RE: DRAINAGE REPORT FOR SANTA FE VILLAGE UNIT III, PHASES I AND II

In response to your letter dated February 26, 1986 we are pleased to submit the following response to your concerns regarding the sizing of sidewalk culverts.

RE: DRAINAGE REPORT SUBMITTAL OF PRUDENT LINE ANALYSIS OF THE  
SOUTH BRANCH OF THE SAN ANTONIO ARROYO RECEIVED APRIL 3,  
1986 FOR PRELIMINARY PLAT APPROVAL OF SANTA FE VILLAGE UNIT  
III, PHASE II (F-10/D6)

DEPRESSED SIDEWALK AT RUNDOWN (TYPICAL)

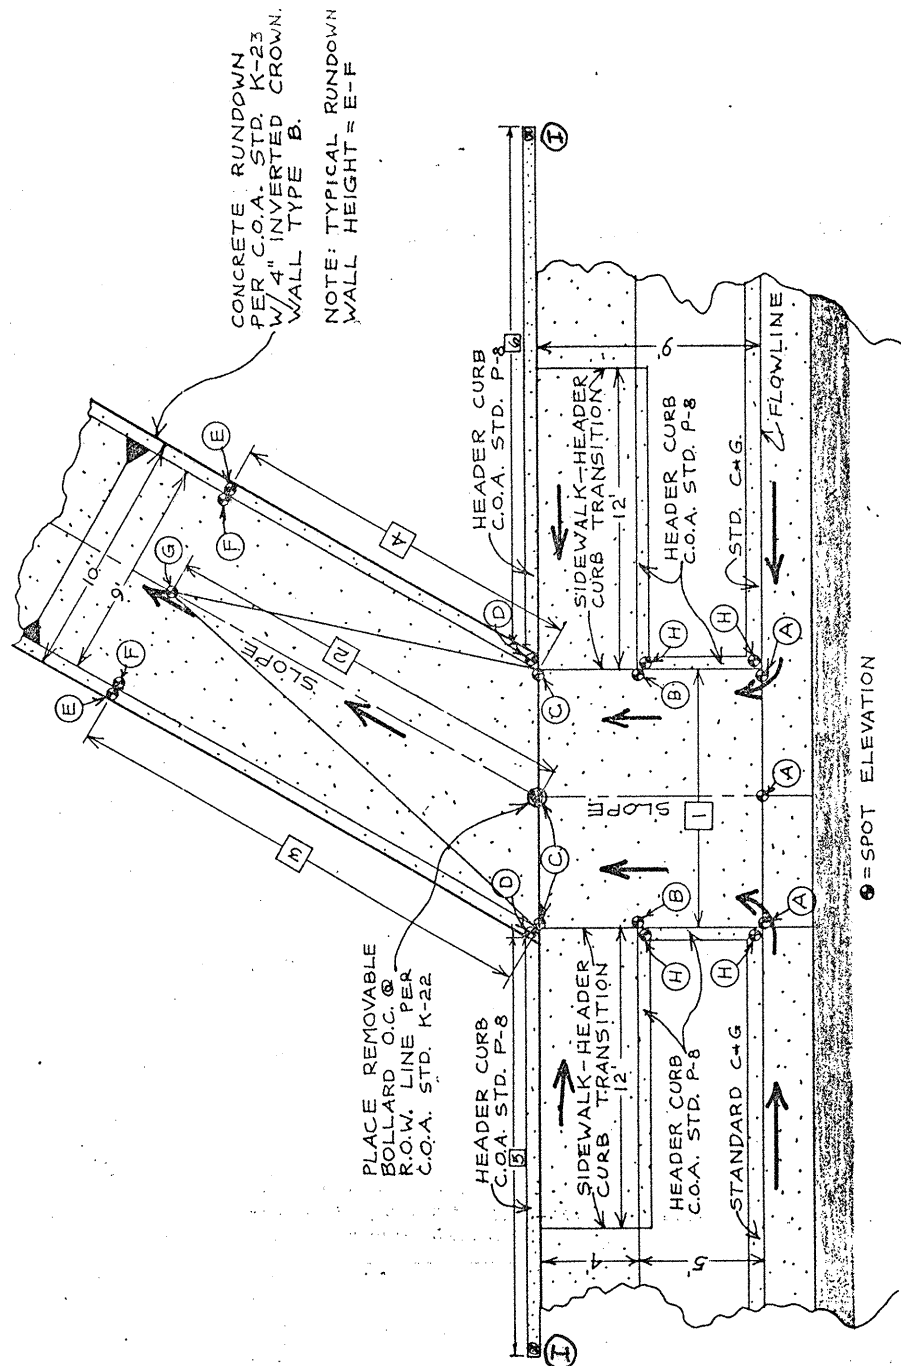
The three concrete rundowns have a 9-foot bottom width; however, only the depressed sidewalk at Butte Place will have a 9-foot bottom width. The depressed sidewalk width at Cliffrose Road and Ja Court are 10.4 feet due to a 60 degree angle of the rundowns with the right-of-way boundary. Figure 1 is a copy of the typical depressed sidewalk-rundown section as submitted on the construction drawings.

The capacity for each depressed sidewalk entrance was determined by the formula  $Q = 0.67 (L)(2(32.2)^{0.5})(H^{1.5})$  (King and Brater, p. 4-5). The capacity of the 9-foot opening with a 0.67-foot curb = 26 cfs. and the capacity of a 10.4-foot opening with a 0.67-foot curb = 30.67 cfs. However, due to the large 100-yr. peak discharge at Cliffrose Road of 67.72 cfs., (assuming that the storm sewer, with 27 cfs. capacity, is not operating) a modification of the typical rundown header curb is necessary to contain the peak discharge as discussed below and shown on Figure 1.

Using the above equation assuming  $Q = 67.72$  cfs. and  $L = 10.4$  feet then  $H = 1.14$  feet (approximately 1.2 feet). To accomodate a depth of 1.20 feet, the header curb at the back of sidewalk will be the same elevation as the rundown wall at Point D (see Figure 1) and the header curb will be extended out until reaching the sidewalk elevation equal to Point C plus 1.2 feet. Therefore, for the 100-yr. peak discharge of 67.72 cfs. (assuming no storm sewer) the water may pond up to the header curb for a few minutes during the peak discharge. The header curb will protect the adjacent lots, and the house slabs adjacent to the rundown will also be raised (from approved grading plan) to add extra safety from flooding.

**FIGURE 2**

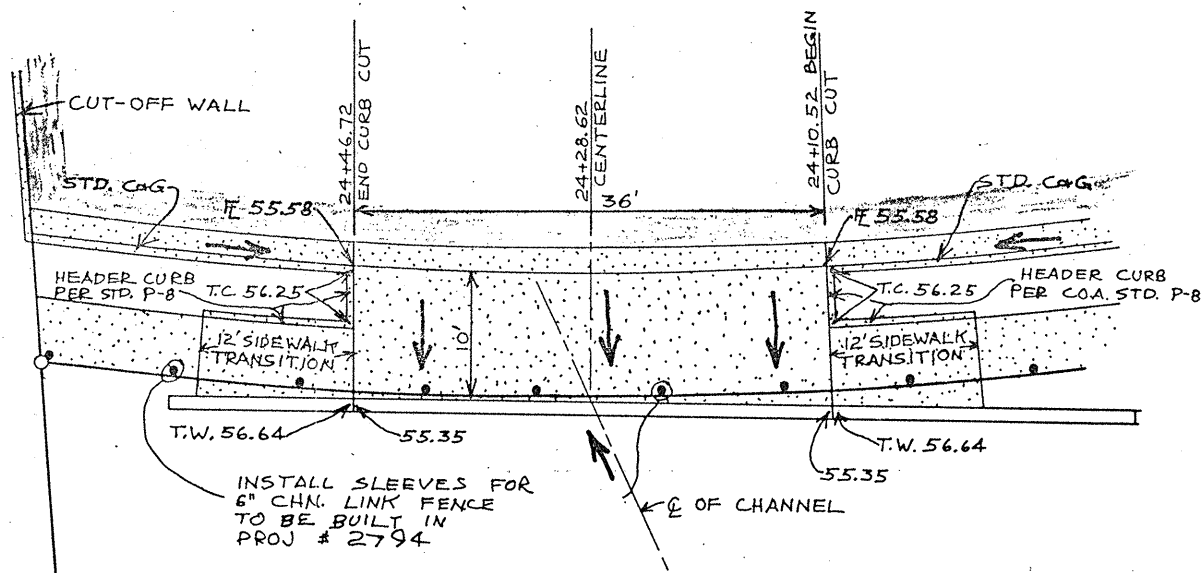
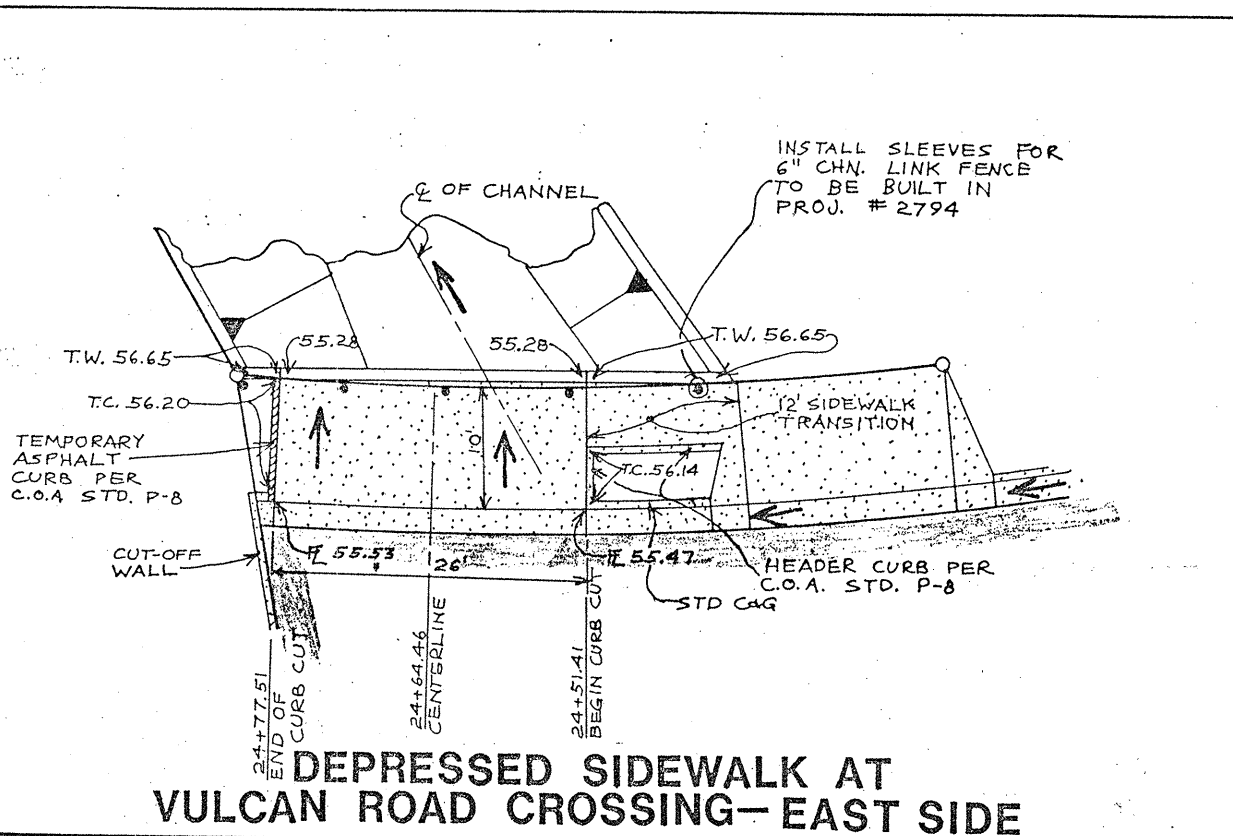
At the Vulcan Parkway crossing, large depressed sidewalks will be constructed on both sides of the street as shown on Figure 2. The 100-yr. peak discharges reaching the Vulcan Parkway crossing from Rincon and Santa Fe Village Unit III are 81.57 cfs. and 25.72 cfs., respectively for a total of 107.29 cfs. The depressed sidewalk lengths required were determined using the formula given above. The length required to pass 53.65 cfs. ( $0.5 \times 107.29$  cfs.) through the depressed sidewalk at each flow line (assuming  $H = 0.67$  feet) is 18.20 feet.

However, due to the large 100-yr.  $Q_p$  of 107.29 cfs., the depressed sidewalk entrance capacity was checked using a weir formula  $Q = CLH^{3/2}$ . The assumed  $C = 3.13$  (Table 5-13, Figure 5-23, King and Brater) and  $H = 0.67$  feet. The maximum length at the east flowline was limited by the concrete channel width and the length of the 12-foot sidewalk transition. The available length = 25 feet and the maximum capacity is 43 cfs. at a depth of 0.67 feet. Therefore 107.29 cfs. - 43 cfs. = 64.29 cfs. which must pass through the depressed sidewalk section at the west flowline. The length of the west depressed sidewalk section is 38 feet. Therefore, the 100-yr. peak discharge will be safely discharged into the channel below Vulcan Parkway.

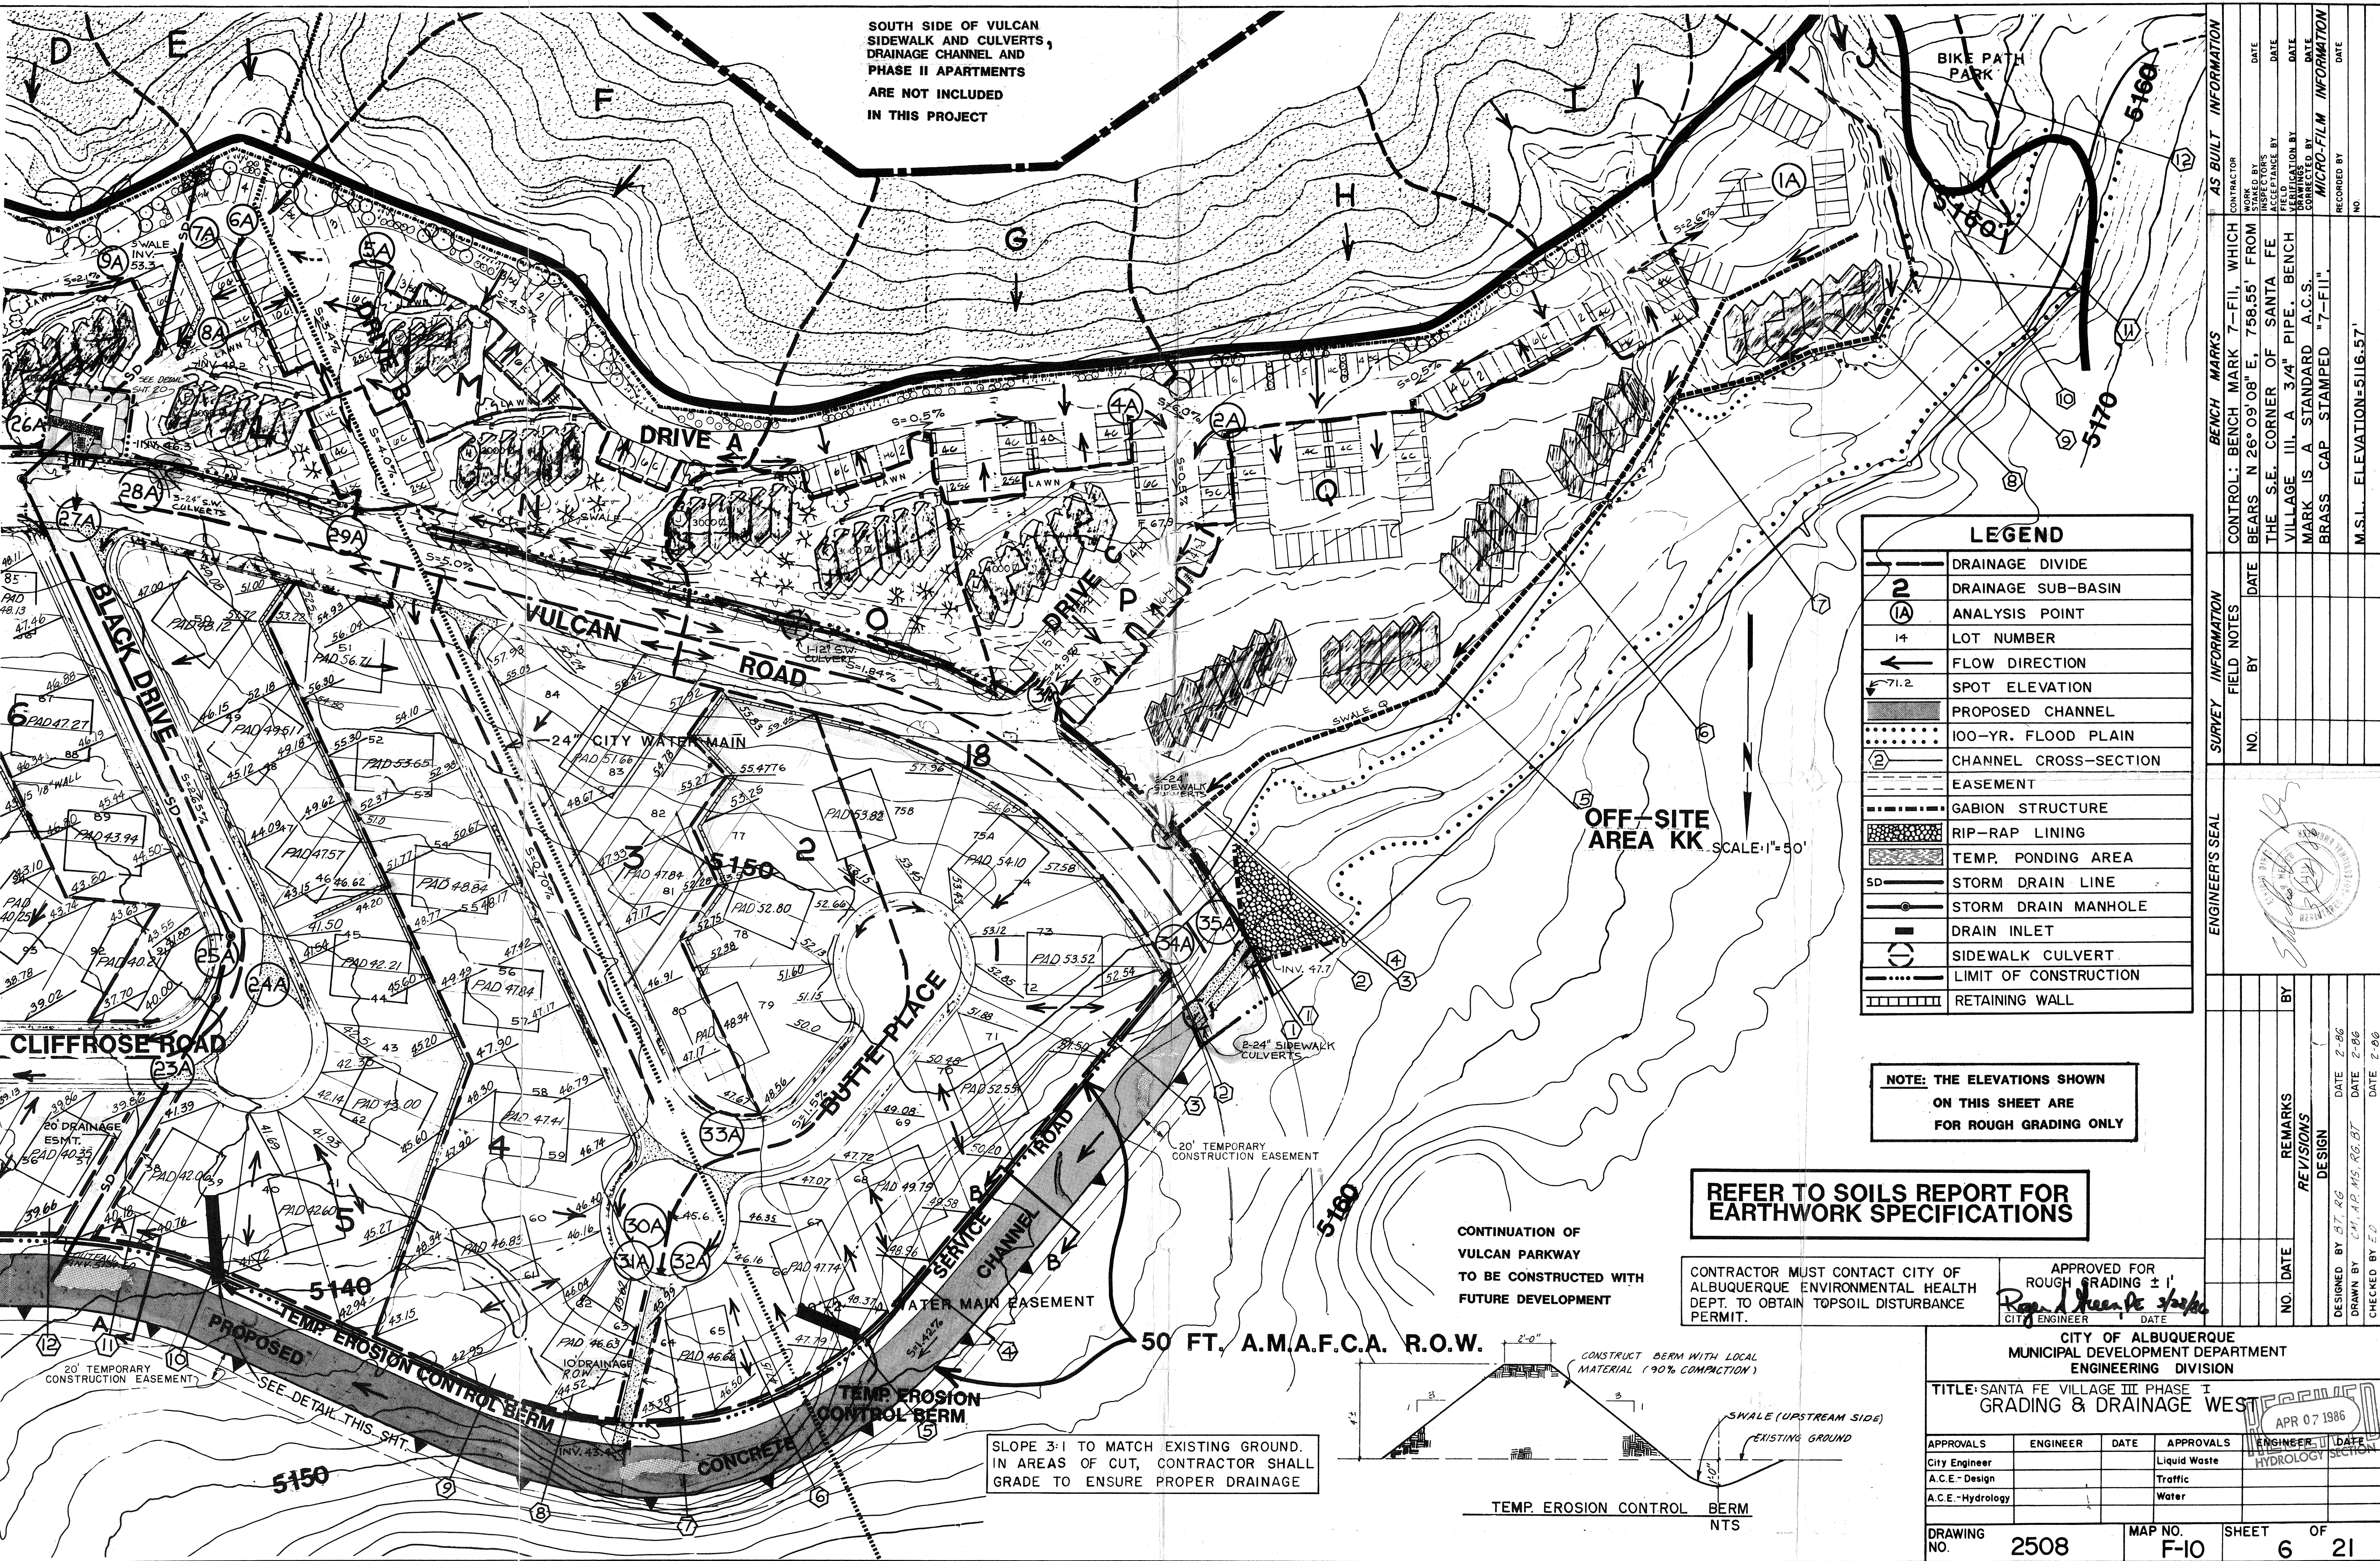
*No, need prudent line, or channel bank Treatment*
